Business & Finance Services

RE: RFP #21-05 – ADDENDUM NO. 1 E-Rate Internal Connections Switches

These are the two pictures provided during the Pre-Bid meeting.

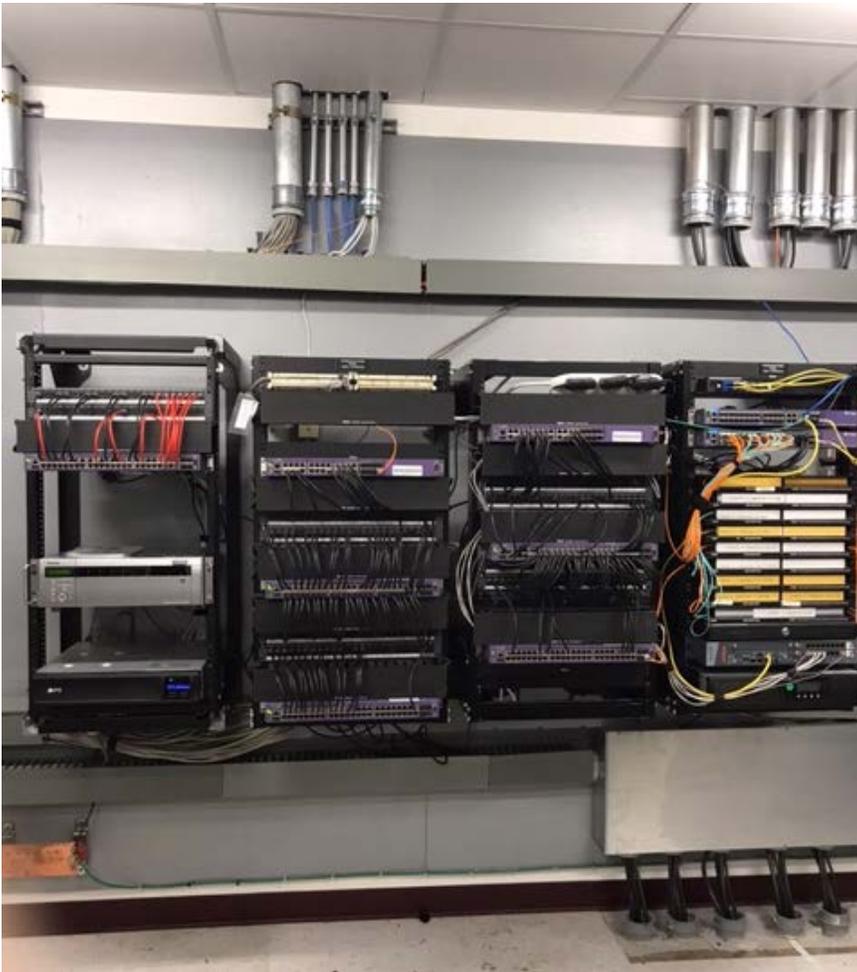
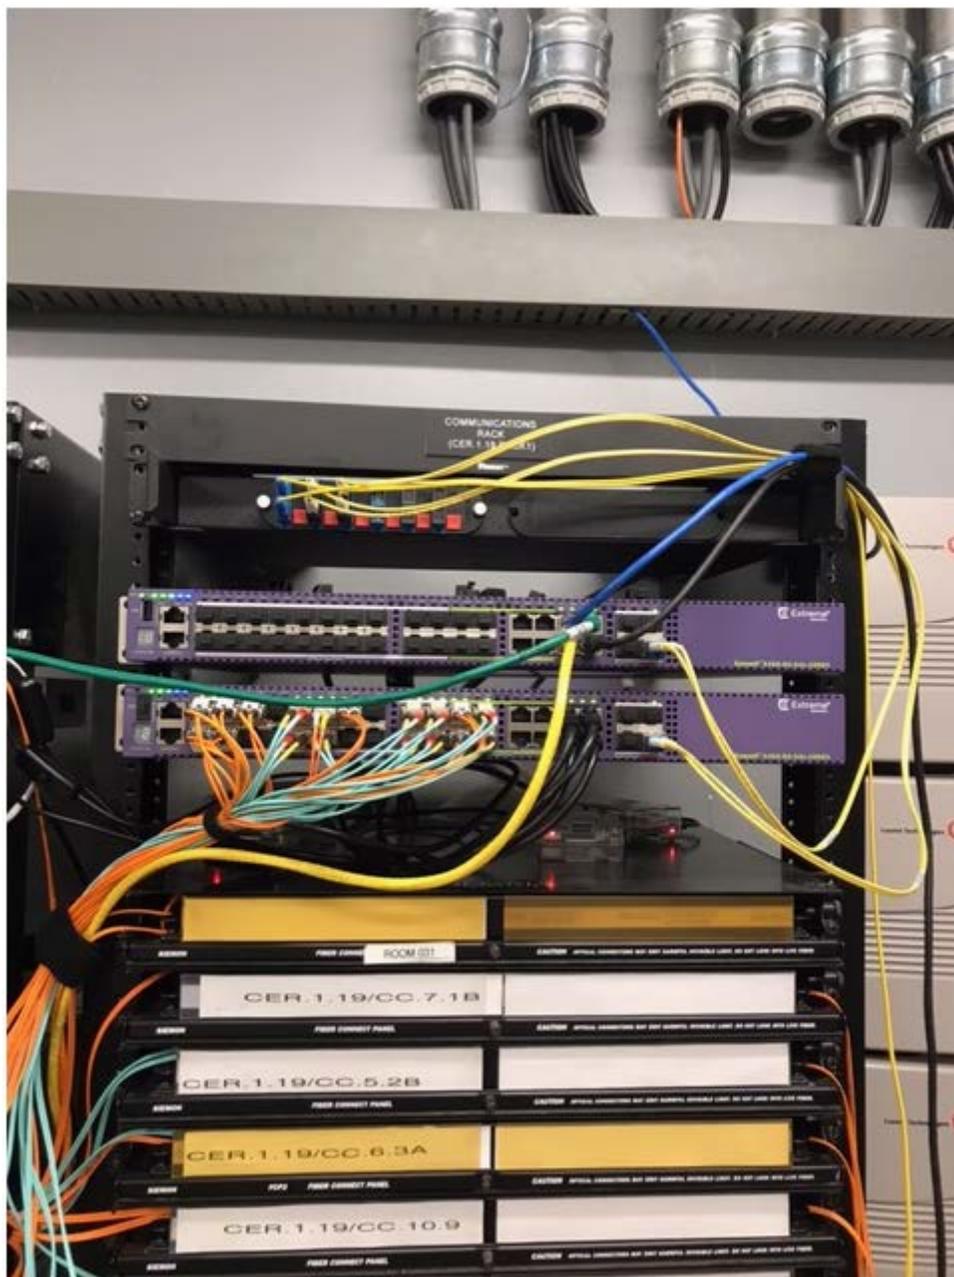
7. What is the expected timeline to replace all 40 switches? One day ? Multiple per day? Etc?
A: Multiple days / weeks on a rolling schedule basis.
8. Can you provide pictures of the individual rooms requiring “clean up” request?
A: We don't currently have a picture of each of the Comm closets for the Elementary schools. This is Northside which is typical for the others.

9. Will there be net new cables required to “clean up” the various rooms? Please provide detailed information for what is required for clean up.
A: 1 foot to 1.5 ft. Cat 6 patch cables should be used to replace the longer cables that may cross from rack to rack.
10. Do you require the SOW with the submission of our bid / proposal or after the intent to award comes out?
A: Yes, SOW with the submission.
